PRODUCT / PROCESS CHANGE NOTIFICATION

PCN#2609009-AU • DATE: 23rd September, 2026

PCN Subject: Additional Assembly Site for SOT-323 Series Automotive Products

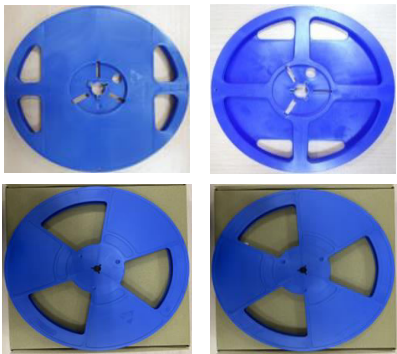
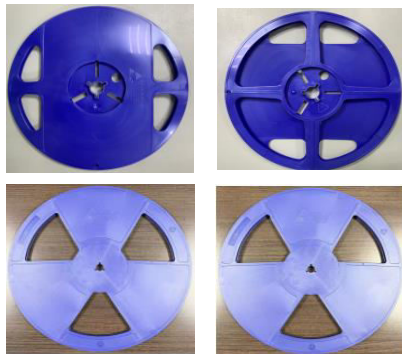
Comparison			Table 1	
			Current	Add
Assembly Site			PANJIT International Inc.	PANJIT Semiconductor (Xuzhou) Co., Ltd.
Production Site Location			Kaohsiung, Taiwan	Xuzhou, China
Package			SOT-323	
Material	Lead Frame	Material	Alloy 42	Copper
	Die Attach	Process	Eutectic	
	Wire	Material / Diameter	Cu / 1.0mil	
	Epoxy Molding Compound	Product Name	ELER-8-500C	KHG500
	Ending Tape	Material	Polyester	Paper
		Color	Black	Yellow
	Plastic Reel			
Form	Marking Format			
			Add bar "-" for new assembly site

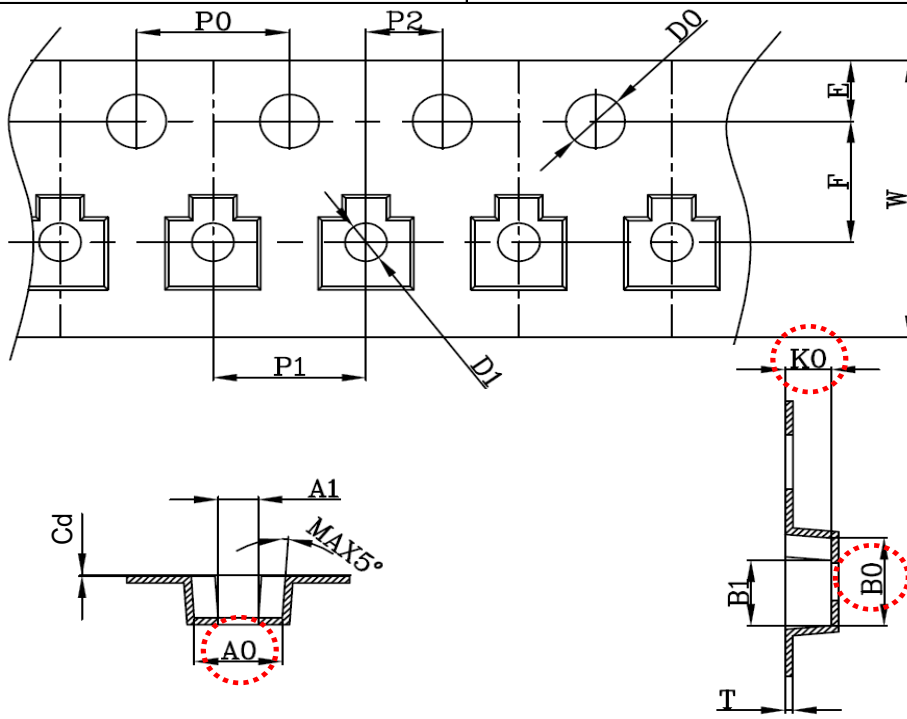
Comparison			Table 2	
			Current	Add
Assembly Site			PANJIT International Inc.	PANJIT Semiconductor (Xuzhou) Co., Ltd.
Production Site Location			Kaohsiung, Taiwan	Xuzhou, China
Package			SOT-323	
Material	Wafer	Supplier	Phenittec semiconductor Corp.	Jiangsu Xinshun Microelectronics Co., Ltd.
		Die size(mil)	10.2x10.2 11x11 11x11 13x13 13.8x13.8 15.7x15.7 16.1x16.1	11.02*11.02 9*9 11.02*11.02 13.8*13.8 13.8*13.8 17.3*17.3 11.02*11.02
	Lead Frame	Material	Alloy 42	Copper
	Die Attach	Process	Eutectic	
	Wire	Material / Diameter	Ag / 1.0mil Au / 1.0mil Cu / 1.0mil	Cu / 0.8mil Cu / 0.8mil Cu / 1.0mil
	Epoxy Molding Compound	Product Name	ELER-8-500C	KHG500
	Ending Tape	Material	Polyester	Paper
		Color	Black	Yellow
	Plastic Reel			
	Form

Add bar "-" for new assembly site
